The scope of this project is a major remodel (>500 sq. ft) and bedroom addition to the main house. The bedroom count is proposed to be increased from 4 BR to up to 6 BR. This as-built plan is to show that the existing septic system serving the residence has adequate capacity for the intensification, and that the system largely meets current septic regulations.

SEWAGE SYSTEM REVIEW
SANTA CLARA COUNTY
DEPARTMENT OF ENVIRONMENTAL HEALTH
Project Description: Major remodel 6 bedroom max
SR No.: 864119

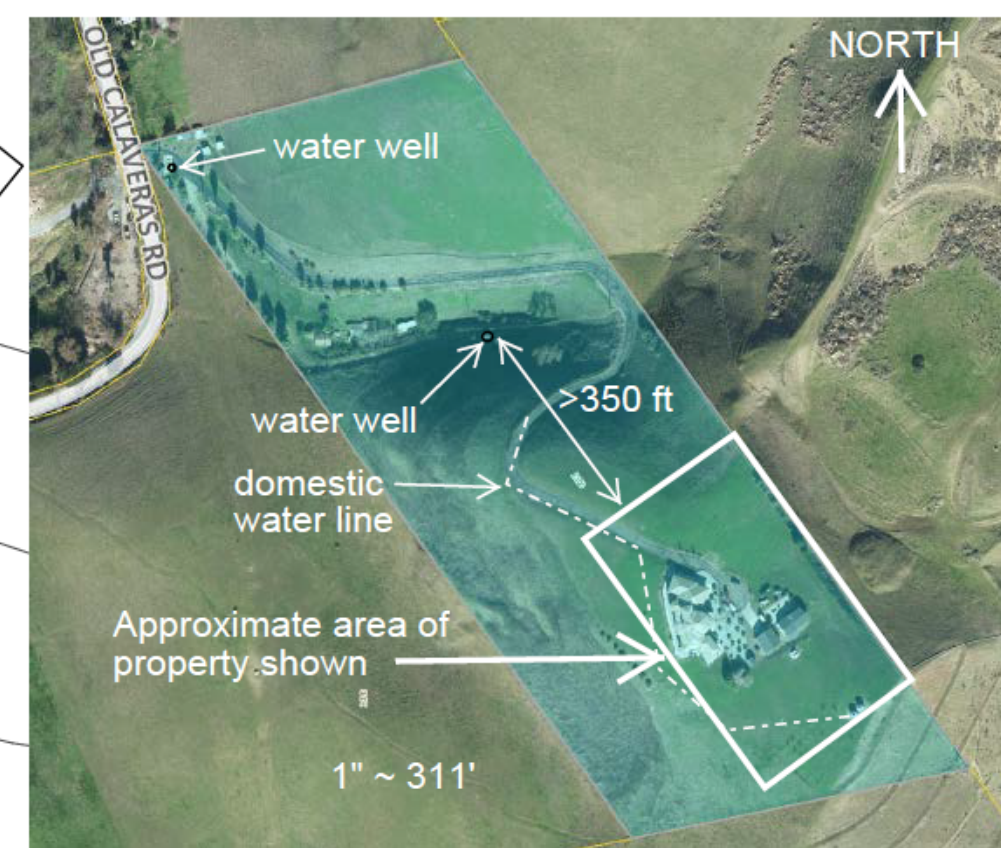
APPROVAL RECOMMENDED
☒ With existing System (Existing No. 61131)
☐ Install/modify system per plan (describe below)
[Obtain a permit from Environmental Health]

Existing OWTs is large enough to accommodate 6 bedrooms
